Technical Note TN-544

Improving The Noise Mute Performance In Series II T855 Receivers

14 December 1998

Figure 1 T855 PCB Modifications - Bottom Side

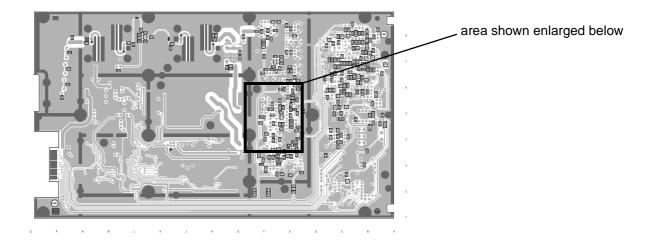
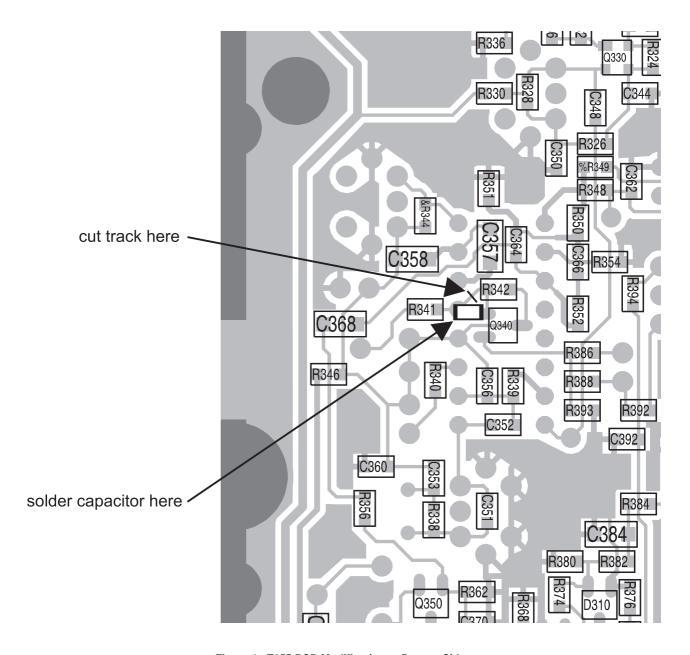
T855 Series II receivers manufactured with PCB IPN 220-01396-02 have a potential problem with noise mute hysteresis. This problem may cause the noise mute to open and stay open, particularly when the receiver is operating in high temperatures and/or noisy RF environments.

- 1. Remove the top and bottom covers.
- 2. Cut the track between R342 and pin 5 of IC310 as shown in Figure 1.
- 3. Solder a 10n 0805 chip capacitor between pin 5 of IC310 and the base of Q340 as shown in Figure 1.
- 4. Check that all the solder joints are of a good standard and that there are no short circuits.
